# City of Seattle

## Seattle Planning Commission

### Discussion Papers on the Proposed Multifamily Code Update

**Fig. 1: Four Towers per block – crowded, economically too skinny, but allowed in DPD proposal**

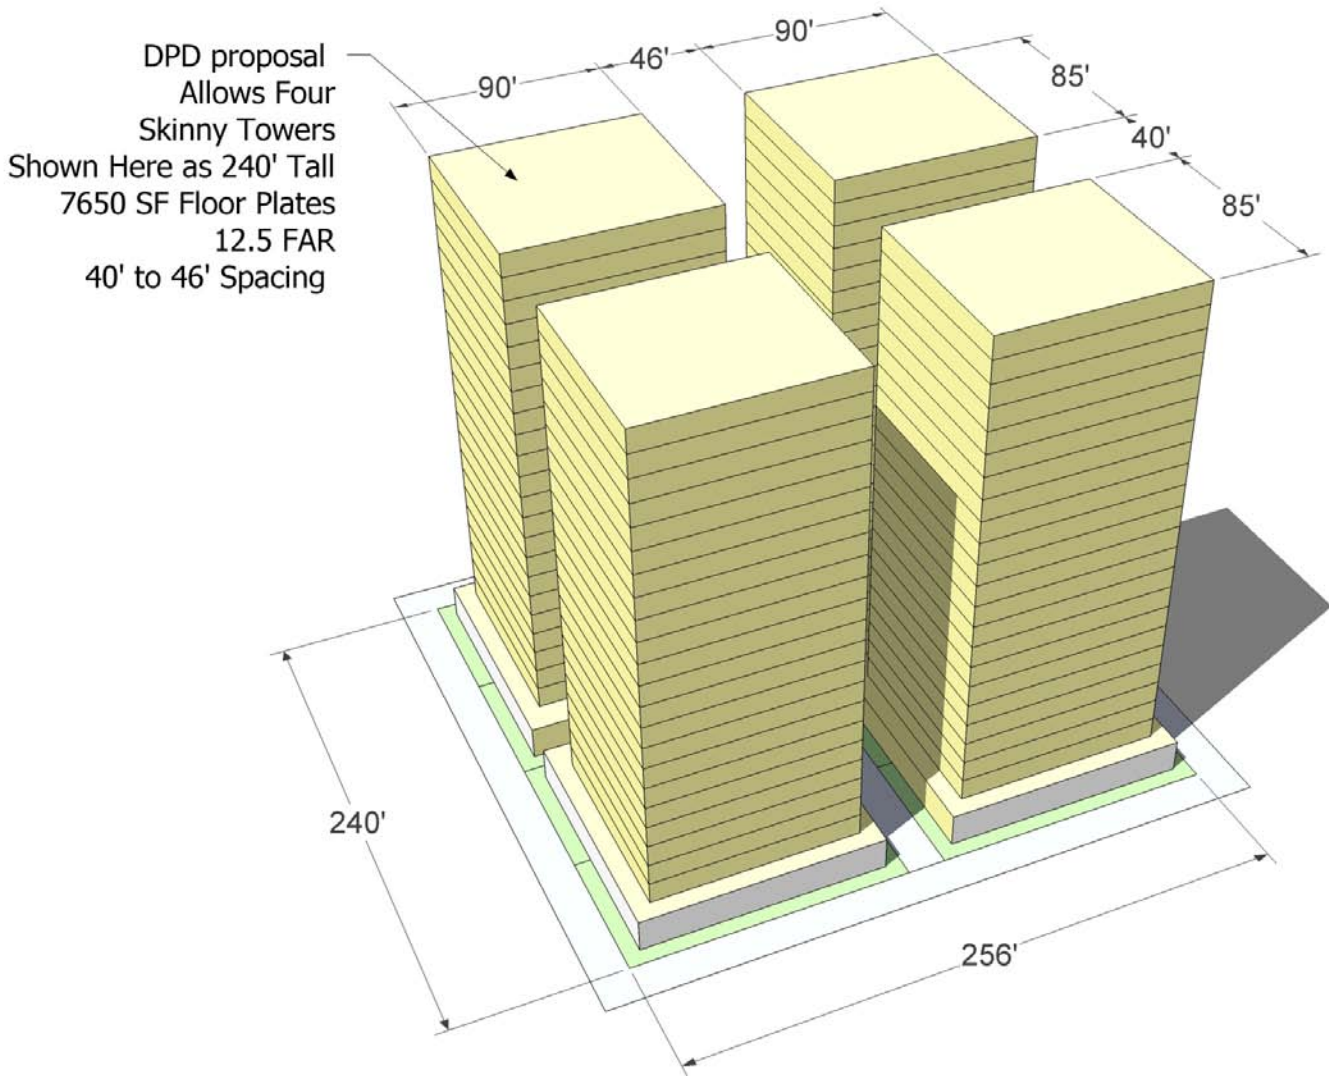
Furthermore, the proposal would actually allow four small towers on a block with just 40-46 feet of spacing continuously between all towers. This is an outcome we do not find likely or desirable. Illustrations in figures 1 and 2 shows a potential outcome of the DPD proposed standards.

**Figure 2: DPD Proposal: two towers on half block sites – overly bulky bases**

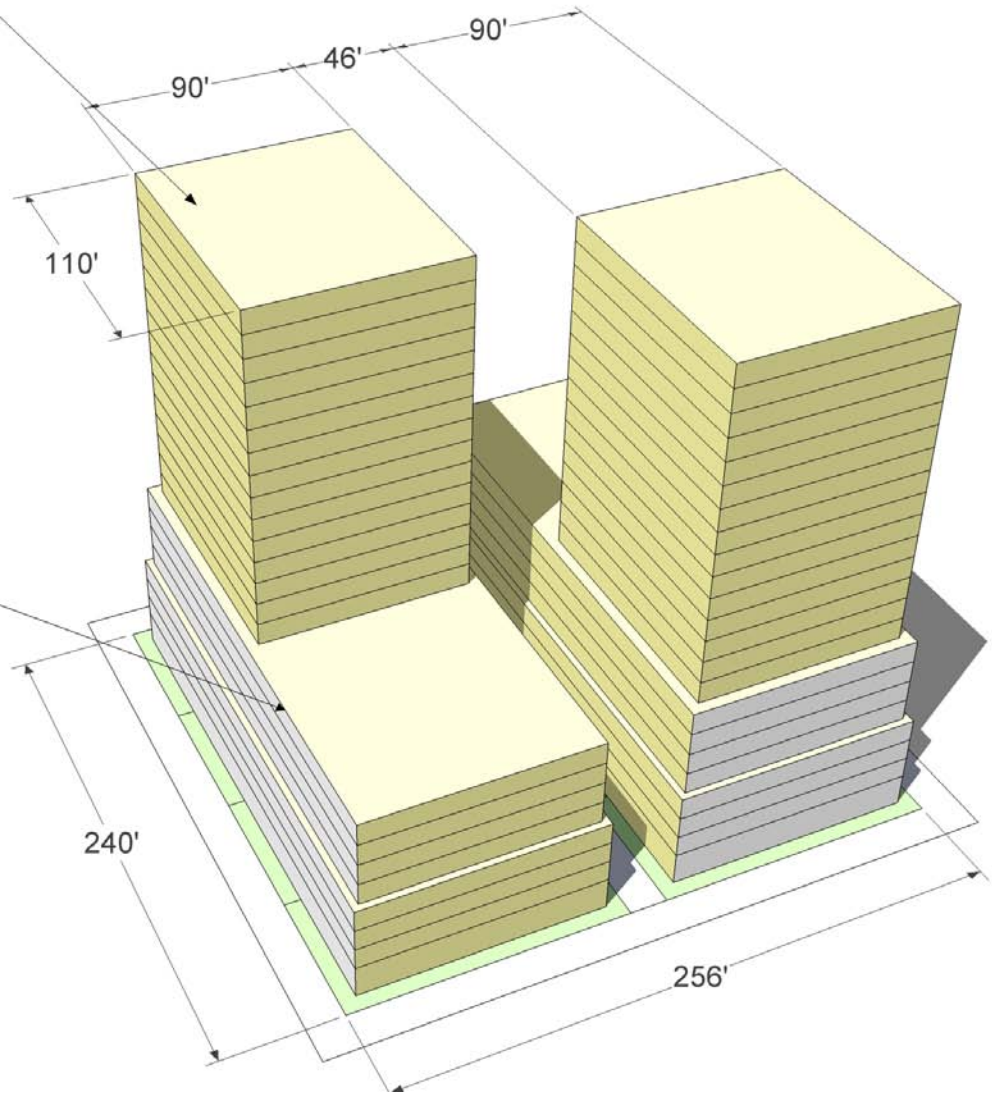
DPD's proposal also allows considerable bulk dimensions below 85 feet. This encourages 'bread loaf' massing and defeats the concept of spaced towers allowing light and air at the street level. We recommend podium portions of towers be limited to 45 feet. This allows a four story street wall. Massing above 45 feet will be subject to the floor plate limits mentioned above. Graduated setbacks are not necessary or desirable, especially when the proposed increments are so small.

**Figure 3: SPC Suggested- 2 towers per block, 60' Min. Separation, Maximum Floor plates of 13,000 SF when 20% of units are affordable.**

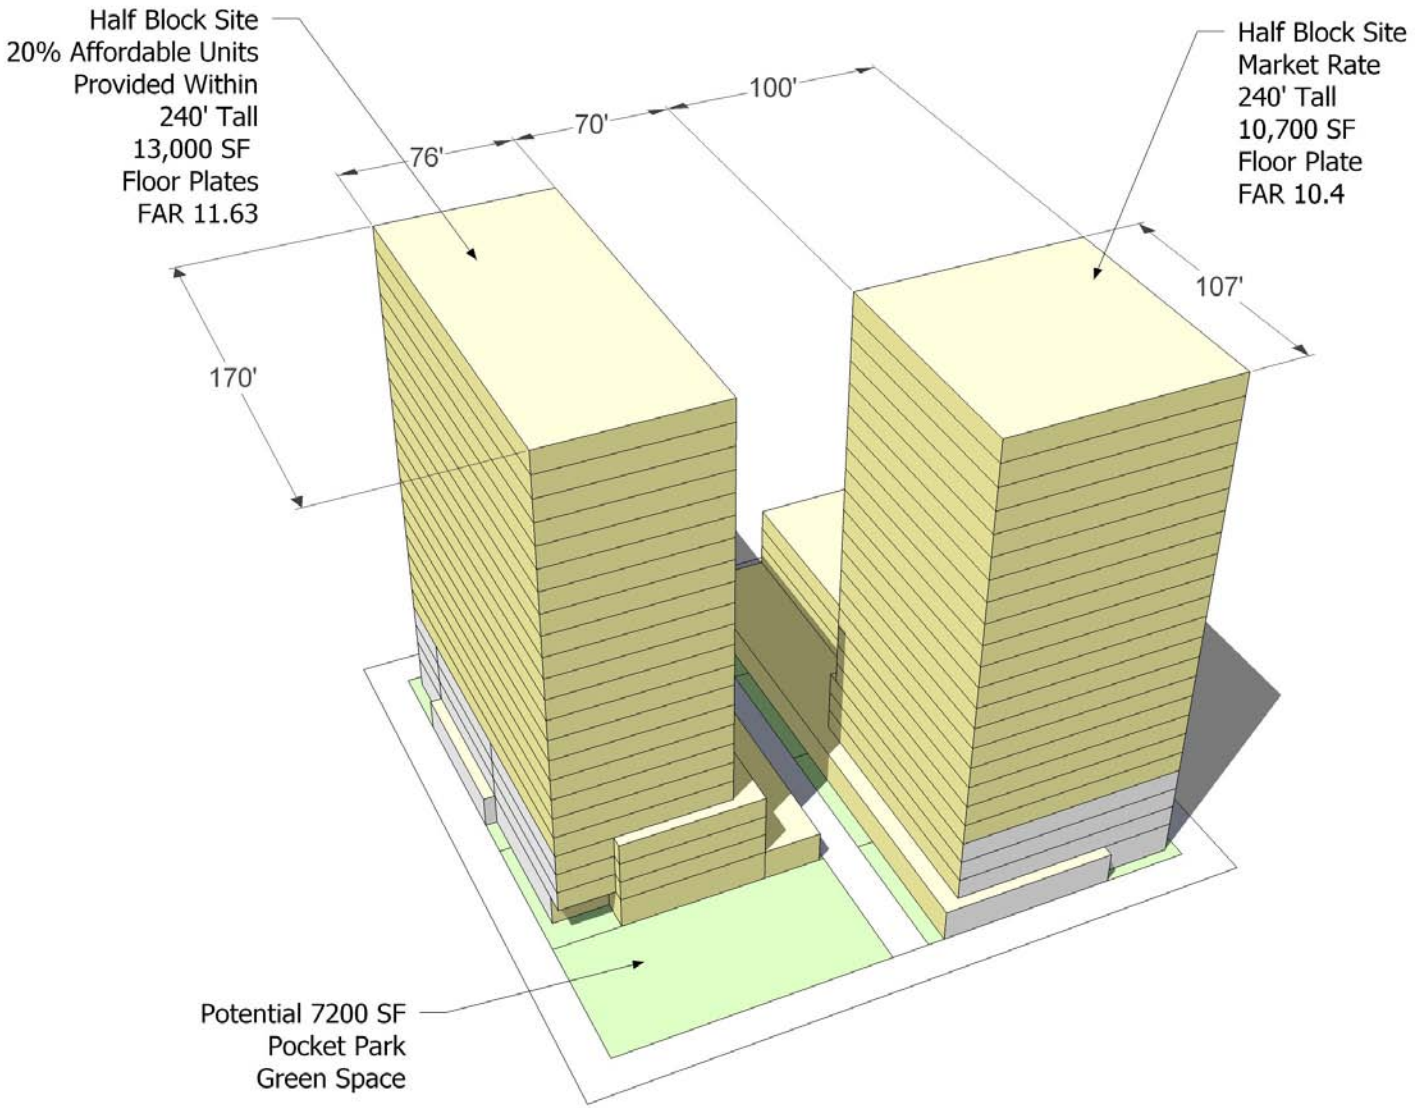
Taking this a step further, we have found that few if any recent Seattle highrise projects are including affordable units on site. For that reason, a greater incentive should be put forward to increase housing diversity in the HR zone. We suggest increasing maximum floor plates and associated FARs to allow up to 13,000 floor plates when 20 percent or more of the units on site are set aside for below median income residents. If projects do not include affordability and choose to write a check for affordability off-site per the proposed incentive program, then those towers should only have a floor plate of 10,000 SF to assure market driven skinny towers. See the massing examples in figures 3 and 4 below.

**Figure 4: SPC Suggested - 2 towers per block, 60' min. separation, one larger/affordable and one skinny tower, market driven with 350' height.**

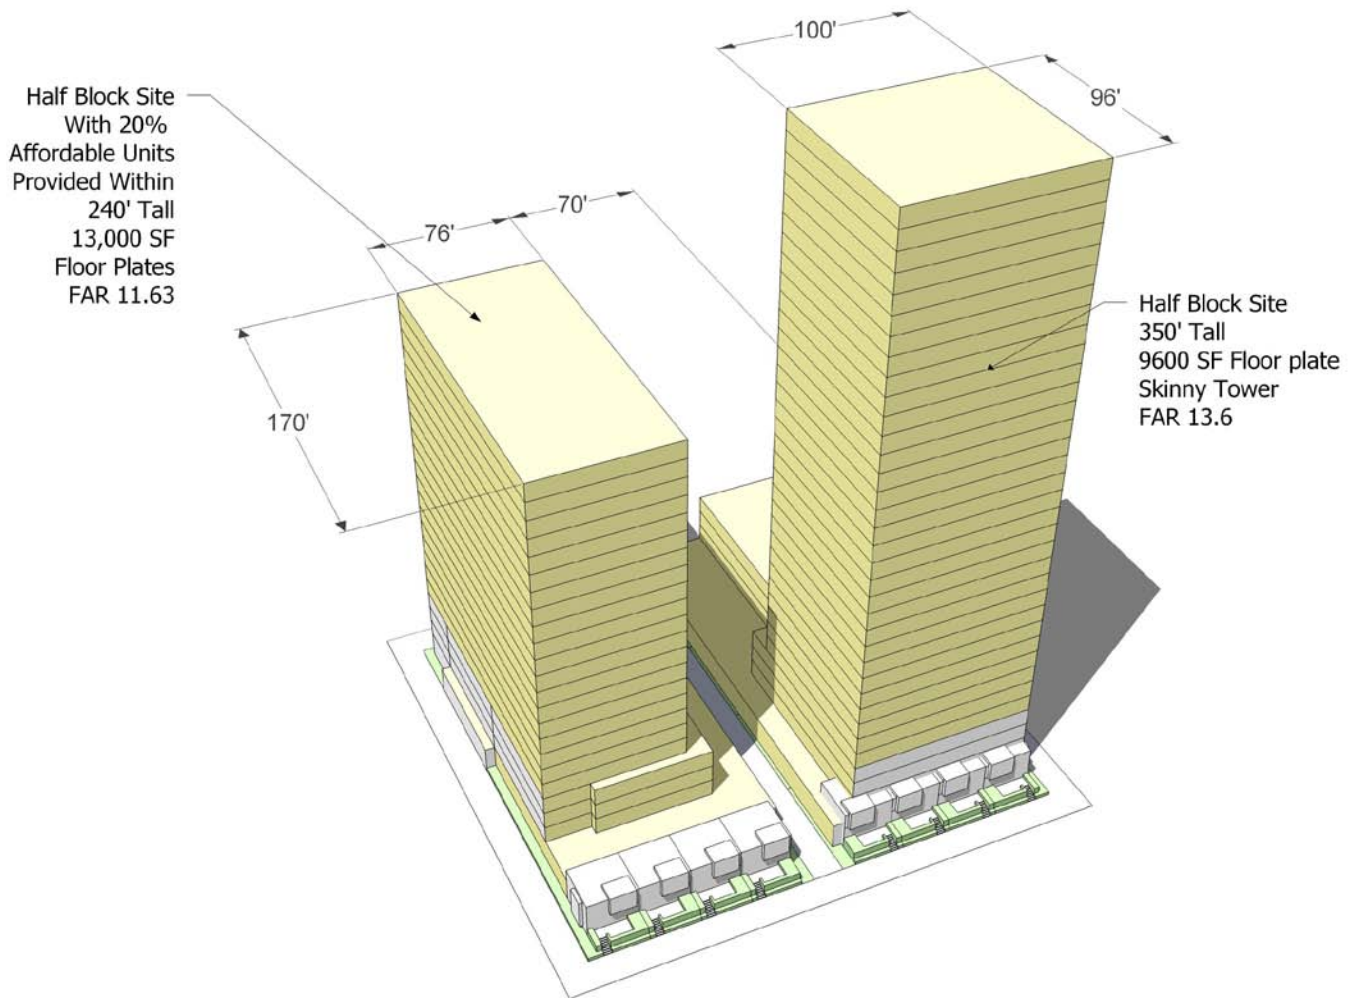
The proposed incentive heights increase from 240 to 300 feet is not significant enough to justify the added cost and time for peer-review, which is required of buildings over 240 feet. We suggest that this increase be more significant, 350 feet, yet subject to true ‘skinny tower’ criteria. Requiring a 9,600 SF floor plate maximum for towers at this height would be a reasonable standard. See the massing example in figure 4 below.
